# Groundwater Transfer Review Summary Form

Transfer/PA # T- 13502 (Evans Ranch Land, LLC [Bobby R. & Billie L. Evans])

Date Review Completed: 30 November 2020

Application: T-13502

# Groundwater Transfer Application T-13502 Evans Ranch Land, LLC (Bobby R. & Billie L. Evans)

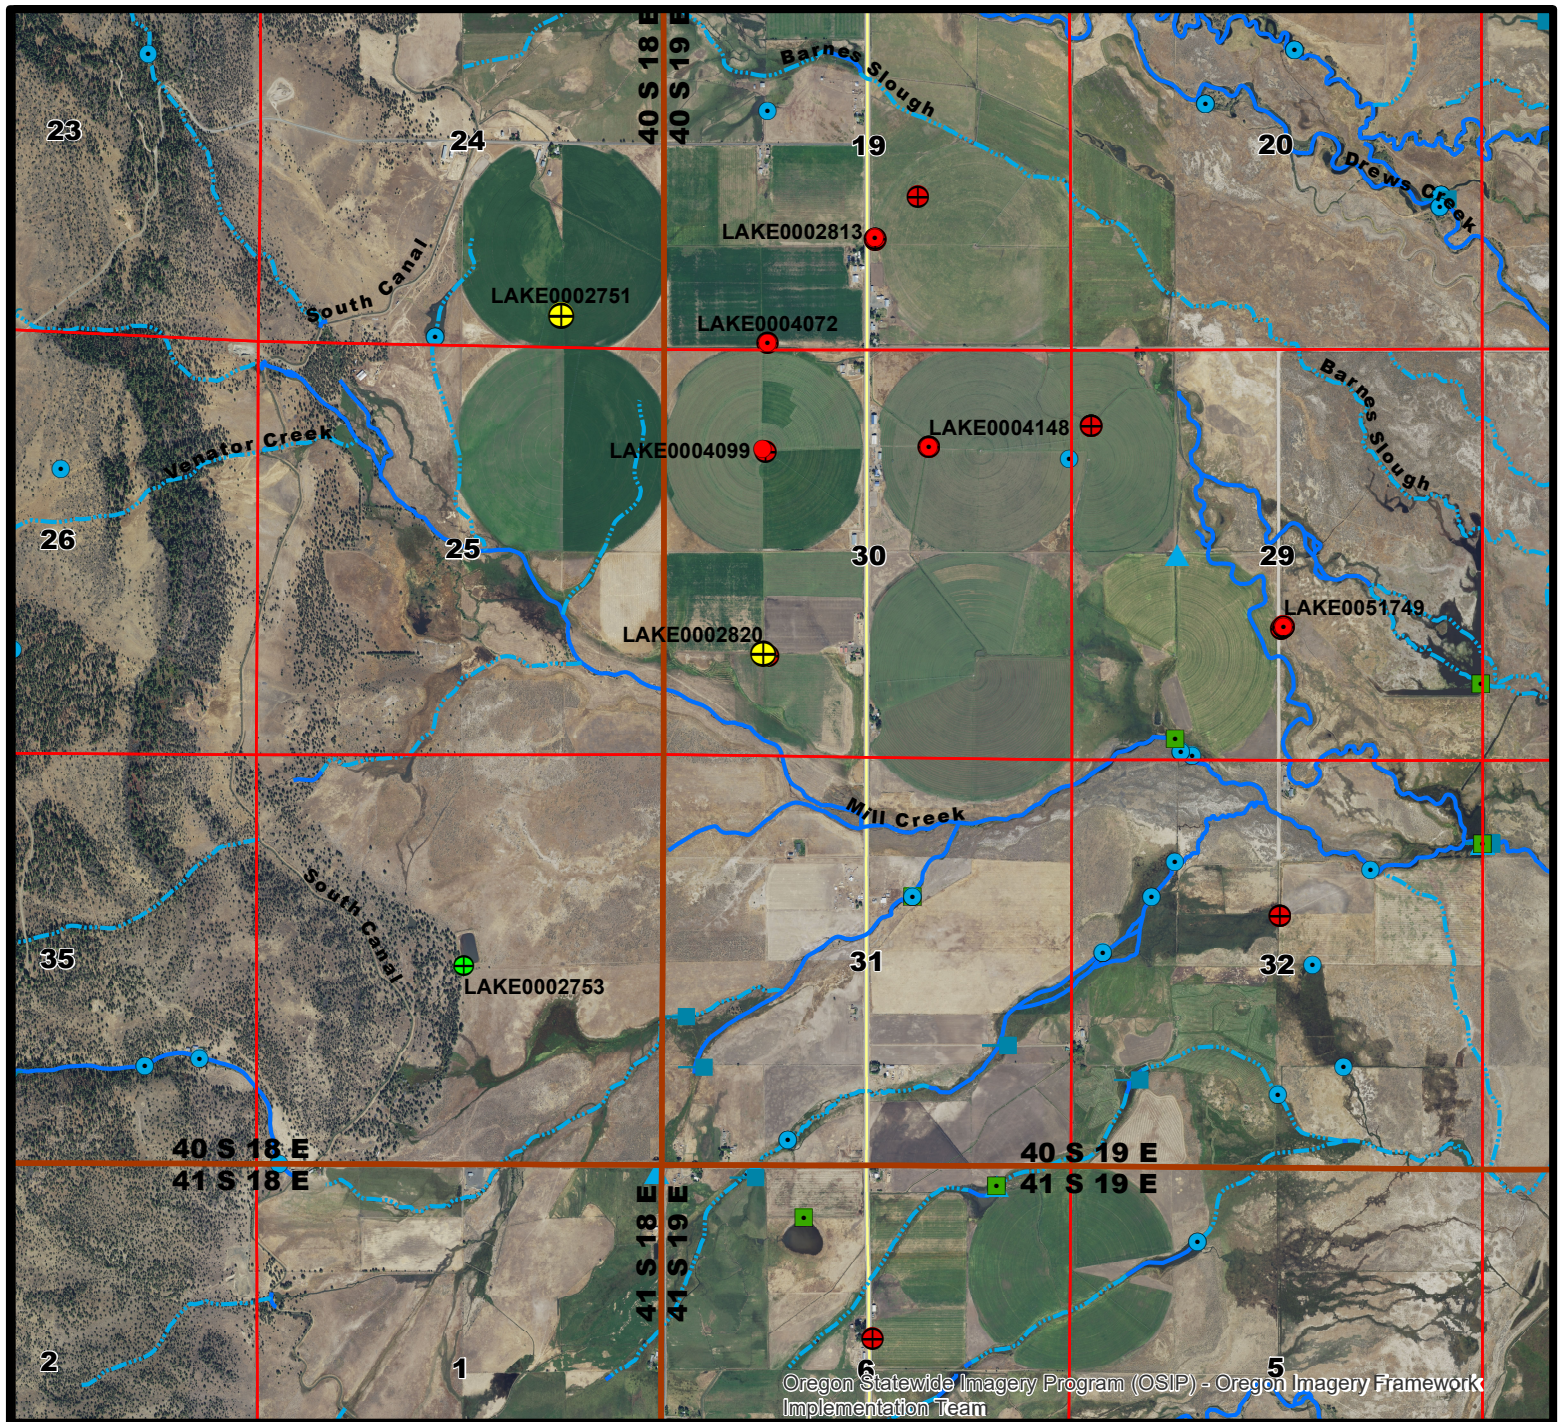
**This transfer application (T-13502) relates to 3 certificates (87093, 95027 and 63146), 2 authorized existing "From" POA wells (LAKE 2751 related to certificates 87093 and 95027 and LAKE 2820 (LAKE 4478 deepening) related to certificate 53146), 1 proposed "To" POA well (LAKE 2753) for all certificates, and moving 60.60, 14.76, and 24.80 POU acres respectively. Note: the fee portion of the application indicates 1.25 cfs total will be transferred, but the water right information portion of the application indicates 4.25 cfs of certificate 87093, 4.25 cfs of certificate 95027, and 1.40 cfs of certificate 53146 will be transferred. It should be 0.76 cfs, 0.18 cfs, and 0.31 cfs to be transferred respectively.**

**Note: the application identifies authorized POA well #1 and authorized POA well #2 as LAKE 2820. Authorized POA well #1 should be identified as LAKE 2751 and authorized POA well #2 is correctly identified as LAKE 2820.**

**Yes.** The proposed POA well will increase groundwater pumping closer to a groundwater right well related to certificate 58073 (LAKE 2914?) located in T41S/R19E-sec 06 increasing the seasonal groundwater level drawdown at that well from 11.4 to 23.0 feet by the end of the irrigation season (245 days)(see attached). The seasonal drawdown should be less at wells further away. The impacted wells should be able to accommodate the additional seasonal drawdown. The long-term (annual) impact should remain the same. The long term (annual) groundwater level trend appears to be significantly climate influenced. The attached hydrograph shows a greater than 10-foot decline during the late 1980s-early 1990s drought and a greater than 20-foot decline during the post 2000 dry cycle.

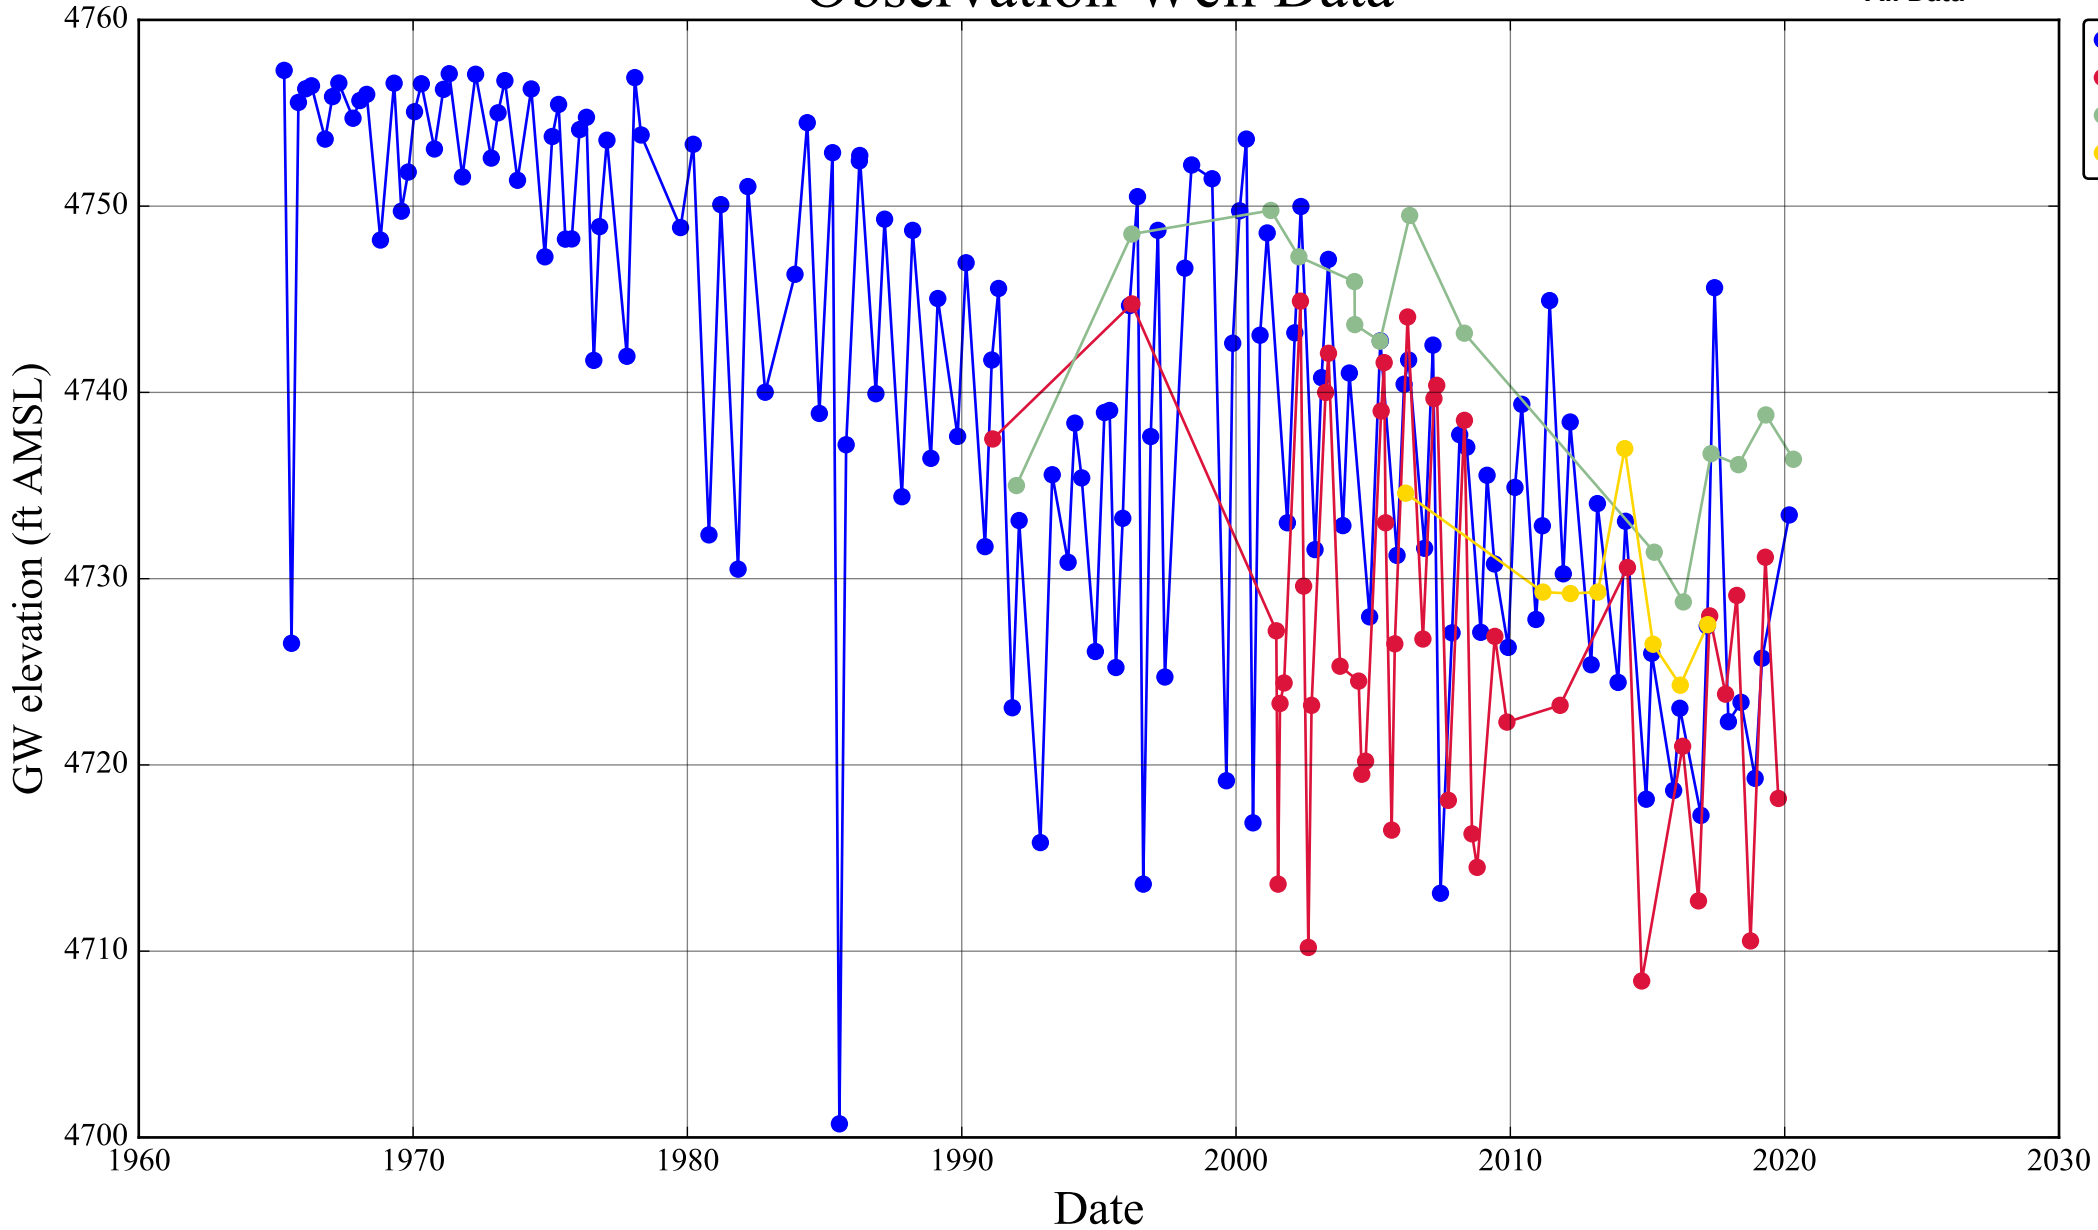
# Observation Well Data
